Ohana Dwelling Permit (OD 91-448) 2424 Tax Map Key: 1-6-87:41, Lot 57

The subject application has been reviewed by the concerned agencies and note:

SITEPLAN FUECOPE

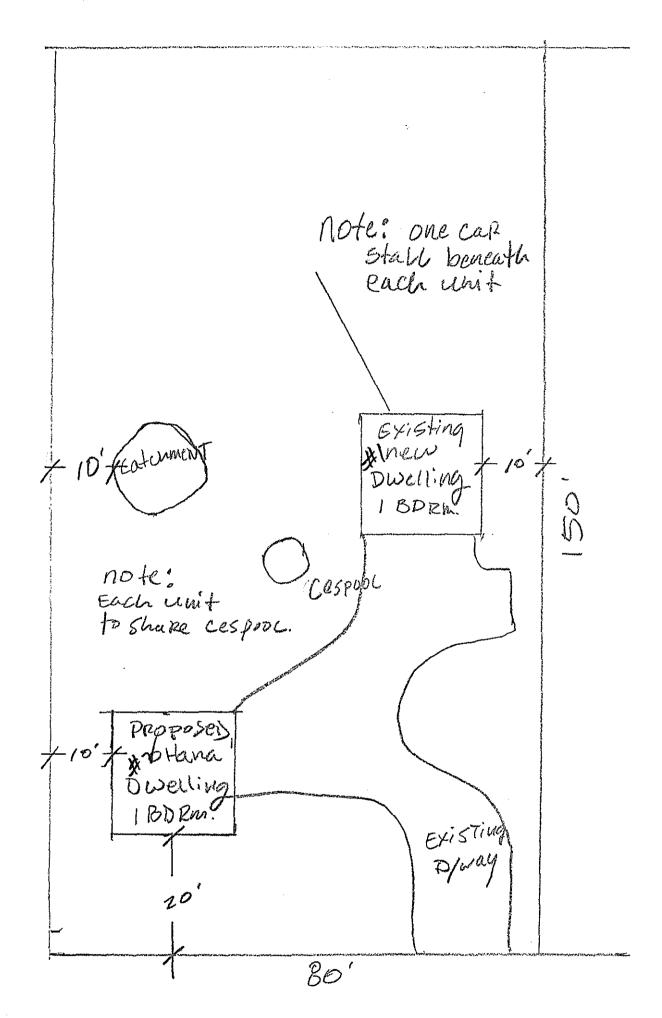
(b) Off-street parking space for two vehicles is designated on the submitted site plan to fulfill the off-street parking requirement. The off-street parking spaces may not be Mr. Adrian Scott Norton Page 2 November 1, 1991

employed for storage or other use unless and until approved alternative on-site parking arrangements are established.

- (c) All construction drawings together with approved site plan drawn to scale submitted with the ohana dwelling building permit application shall denote location and identify required two (2) off-street parking spaces.
- (d) The ohana dwelling shall conform to all requirements of codes and statutes pertaining to access and building construction.
- (e) The applicant shall conform to State Department of Health standards and regulations and following comment(s) dated October 30, 1991:
